P 531903

**SAND-MOUND
ON-SITE SEWAGE DISPOSAL SYSTEM
HOWARD COUNTY HEALTH DEPARTMENT
BUREAU OF ENVIRONMENTAL HEALTH
Tax ID # 04-371305**

SUBDIVISION: The Chase at Stoney Brook LOT NUMBER: 7

SCALE 1"=50'	DATE 09/16/09	ROBERT H. VOGEL ENGINEERING, INC. ENGINEERS - SURVEYORS - PLANNERS 8407 MAIN STREET ELLCOTT CITY, MARYLAND 21043 TEL:410-461-7666 FAX:410-461-8961	WALL CHECK DRAWING LOT 7 THE CHASE AT STONEY BROOK PLAT No. 18648 4th ELECTION DISTRICT HOWARD COUNTY, MARYLAND
DRAWN BY A.M.S.	CHECKED BY T.M.H.		
PLAT NUMBER 18644-18649	JOB NUMBER 06-034.00

Sand Mound Specs

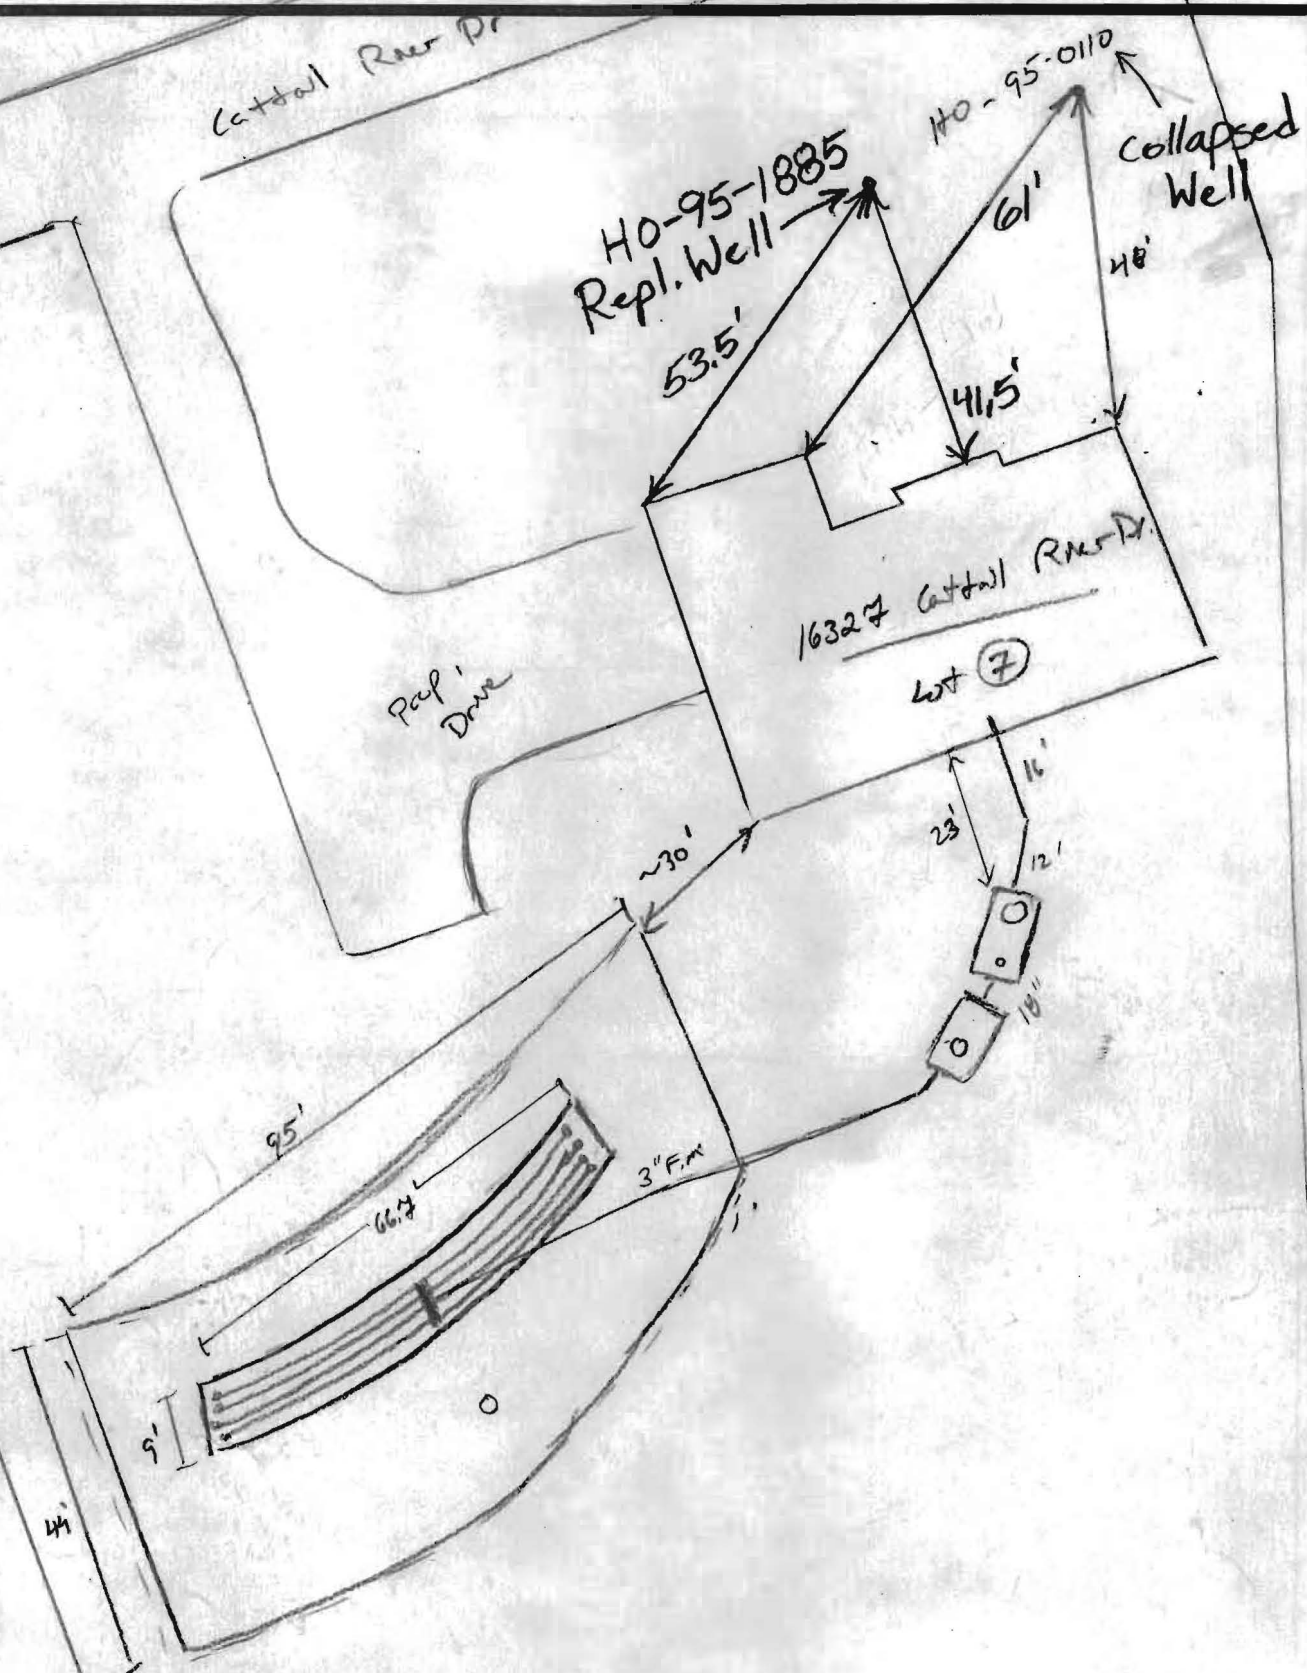
4/30/10 Had
installer remove
lateral end holes
on all turn-ups.
Head now 2'8" in
turn-ups. Alarm
working. (BB)

PRE-CONSTRUCTION
10/6 mound (for slope)
adjusted to level contour
Bed adjusted same. will
wrap slightly. Contractor
can make wrap or 'V'

shaped (chevron mound). Sand on-site. All sand from Garrett, Frederick MD. 0
10/9/09 Gave OK to contractor to plow and lay sand. Site prep. confirmed
INSTALLATION: 10/16 (Rainy Day) Mound shaped, Bed cut out w/ grad.
no pipe work installed. Tanks set. OK to continue. (yes)
10/19 Gravel installed in bed. Bed level. Piping installed per plan
Tanks set w/ plumbing. Test of system performed. # of holes and
spacing and laterals OK. OK to cover laterals w/ grad, cap w/
loom on site and top soil. Will need final p/a but it appears
pump on system for final approval (KW)

FINAL INSPECTOR B. Baker DATE OF APPROVAL 4/30/10
4/26/2010 Alarm working. Head in laterals only ~14". Suppose
to raise pump 6"-8" (BB) 4/27/10 Head 17" in turn-ups (BB)

DETAIL: 1"=30'

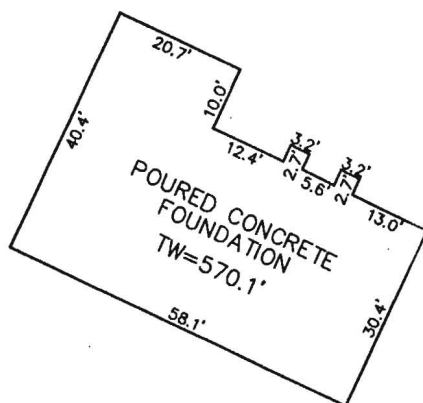
Wall - Check

OK

Approved as Shown
9-22-09
